# SERVICE BULLETIN

## Wheel Spacers

Model #: All

Date: 4/1/2008

Typical 6" Brake Caliper (rear)

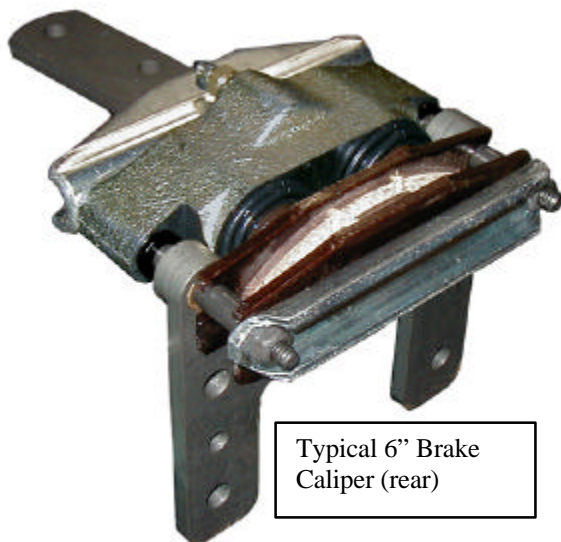
The Taylor-Dunn rear 6" disc brake caliper and the Dana transmission brake drum are only slightly smaller than the wheel. There are aftermarket wheels that will make contact with the brake caliper or drum.

Two wheel spacers are available (4-hole and 5-hole patterns) that should eliminate the contact issue. Use only one spacer per wheel. If more than one spacer is required then the wheel is not compatible with a Taylor-Dunn vehicle.

If a spacer is installed on the left front or rear axle, then a spacer should be installed on the opposing right front or rear axle even if it is not required for wheel clearance.
